Request for Class II Permissive Change

FCC ID: VG8EAM142AYY

Please be notified that we, the undersigned, **Guangdong Midea Kitchen Appliances Manufacturing Co.,Ltd.** declare that the reasons for this class II permissive change are as below:

1. Changed Mother -board as below.

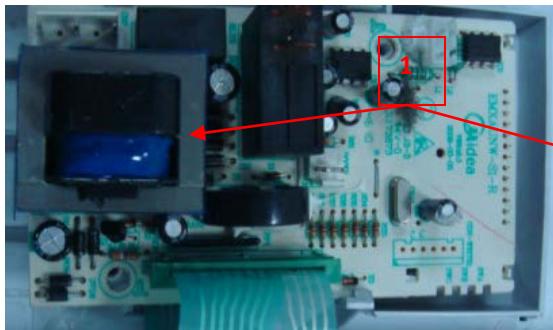
Original Mother board-top view

New Mother board –top view

Note 1: Changed linear transformer to switching power supply. Between two mother-boards have the same input&output power and the same of circuit function.

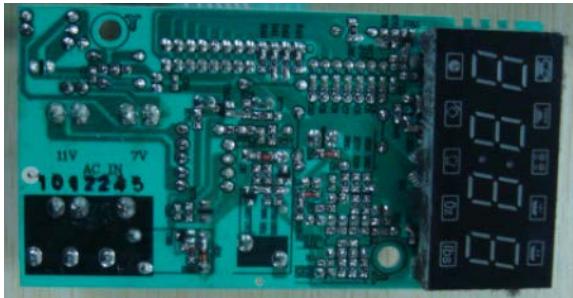
Original Mother board -bottom

New Mother board -bottom

Only differences for component and PCB Layout.
